10 CFR Part 53: Risk-Informed, Technology-Inclusive Regulatory Framework for Advanced Reactors

Preliminary Proposed Rule Language: Risk-Informed, Technology-Inclusive Regulatory Framework for Advanced Reactors

Comments on NRC-2019-0062

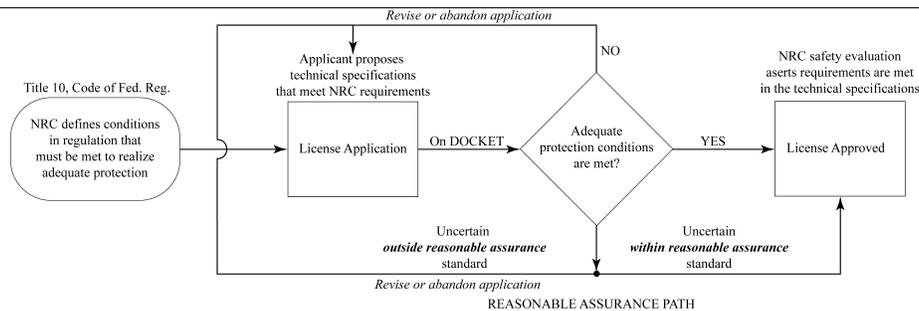
Comment Addition of the qualifier “reasonable assurance” to “adequate protection” in the Proposed language in §53.20, Subpart B - Technology-Inclusive Safety Requirements, appears to imply that adequate protection may not necessarily need to be met in a plant’s licensed condition; this change may lead to loss of the public trust in the NRC ability to assert adequate protection.

The concern This reviewer’s concern is addition of the qualifier “reasonable assurance” to adequate protection leaves open the possibility that adequate protection may not necessarily be met in a plant’s licensed condition. The public trusts the Commission is able to define the conditions that must be met for adequate protection; this reviewer’s understanding is that by statute, the Commission has complete control over the conditions that must be met for adequate protection. It seems that conditions required by regulation are either met or not; if they are not met, the Commission should not grant a license or license amendment as applicable. In summary, if the Commission is either unable or unwilling to assert license conditions it requires for adequate protection are met in a plant license, the public should rightfully be skeptical about adequate protection of their health and safety.

Adding “reasonable assurance” is either a distinction without a difference, or it means the Commission intends to meet a standard different than “adequate protection”. If it is a distinction without a difference, then it seems “reasonable assurance” could be removed without changing the intent of the rule. On the other hand, if it intends to establish a standard different than adequate protection, then the new standard should be explained; but it should retain the adequate protection standard.
